INSPECTION - ELEVATOR BELLCRANK PIVOT

- A. EFFECTIVITY PAL 750XL aircraft up to and including S/N 215.

- B. REASON It is possible that the Elevator Bellcrank Pivot joint could be assembled with a bolt that is a gauge size too short leaving threads inside the working section of the joint. This can be determined by measuring the length of the bolt. If it is found on inspection that the shorter bolt has been used to assemble this hinge, the bolt will need to be replaced with the next gauge size up.

FIGURE 1 LOCATION OF ELEVATOR PIVOT JOINT

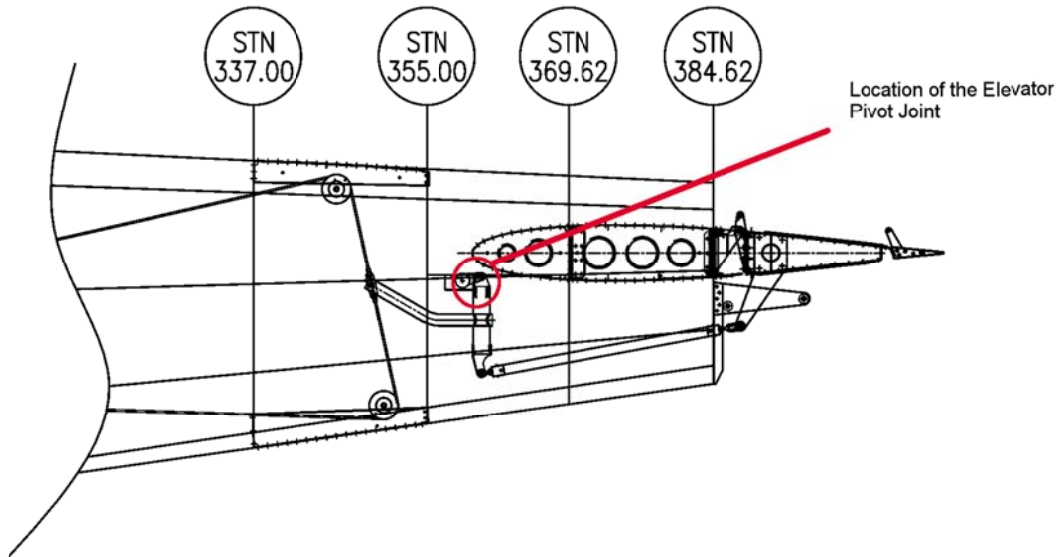
- 1) Remove the Control cable cover (Ref. 750XL MM, Chapter 12-00-00, p. 301, Panel F5) to access area of the Elevator Bellcrank Pivot joint (See Figure 1).

FIGURE 3 RIVET LOCATIONS

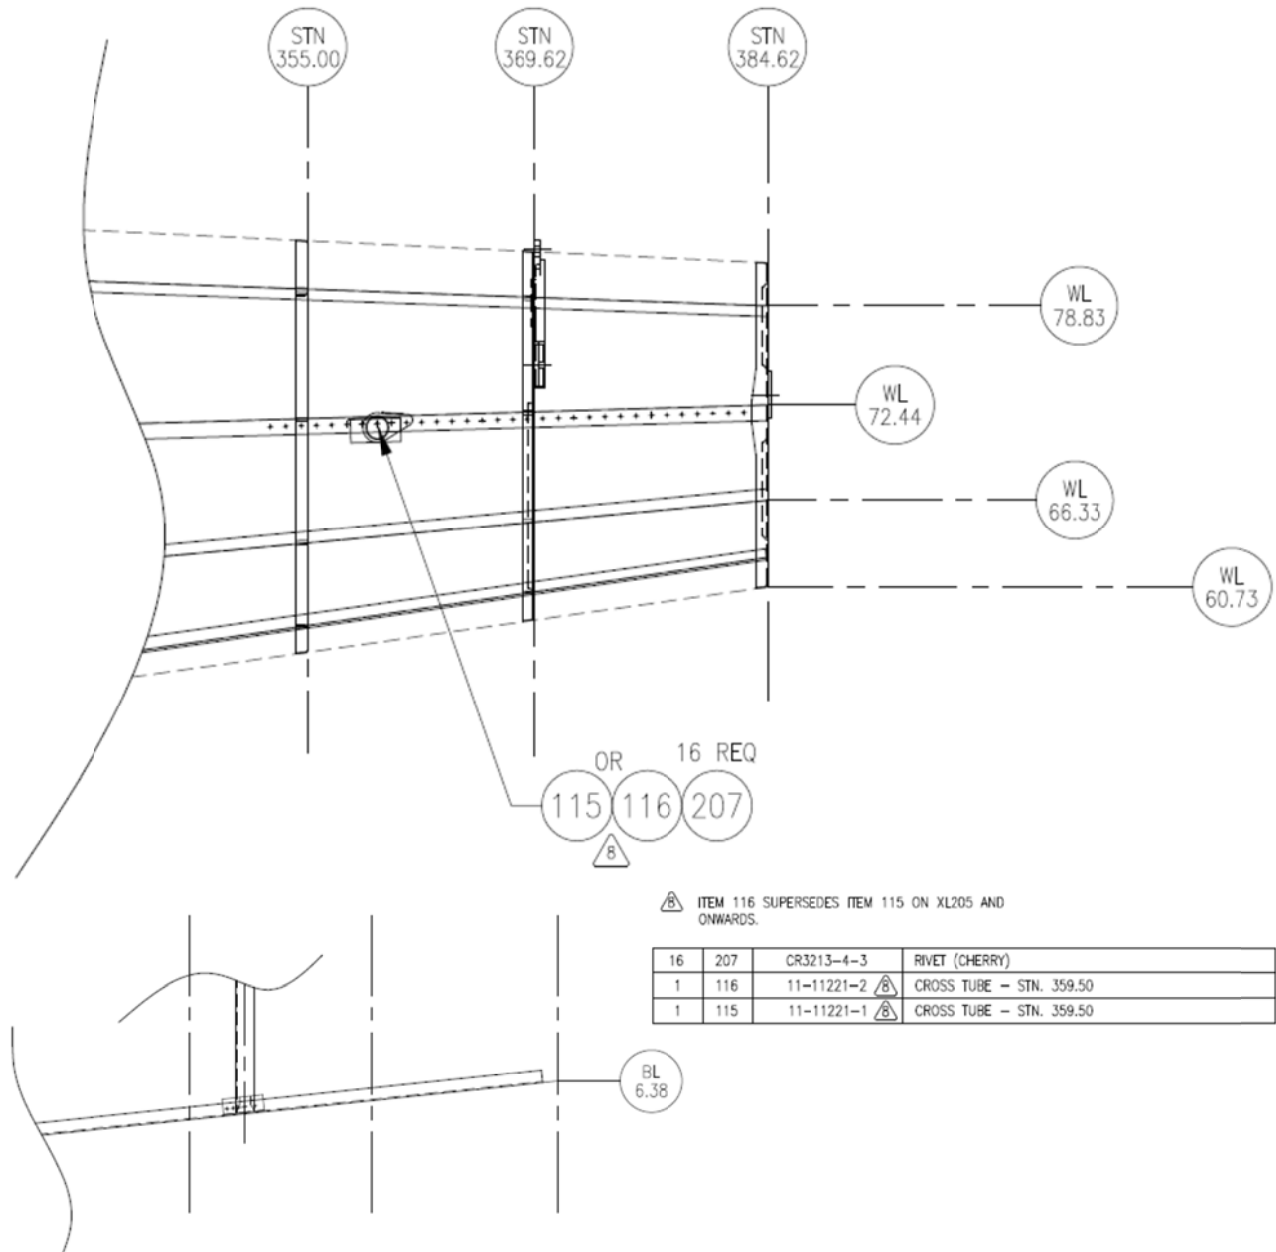
- 7) If damage is detected, remove the Cross Tube from the aircraft by drilling out the attachment rivets (See Figure 3) in accordance with the manufacturer’s rivet removal procedures listed in CA-1015 (Cherry Aerospace Process Manual).

- 11) Install the Cross Tube into the aircraft at STN 359.50 using Cherry Rivets P/N CR3213-4-3 (Qty 16, See Figure 3).

NOTE: If the fastener holes were damaged during the removal of the rivets in Step 7) it will be necessary to install oversized rivets, P/N CR3243-4-3.

FIGURE 4 ELEVATOR PIVOT JOINT – WITH REPAIR P/N’S

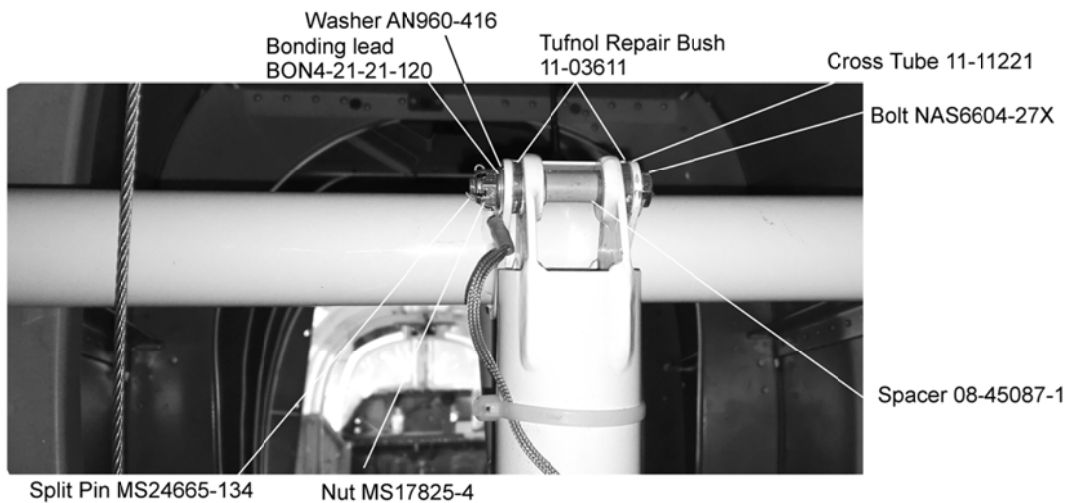
- 12) Connect the Elevator Bellcrank with the Cross Tube IAW Figure 4, replacing existing tufnol bushes P/N 242001-2 (Qty 2) with oversized repair tufnol bushes 11-03611 (Qty 2) and using oversize repair bolt NAS6604-27X.
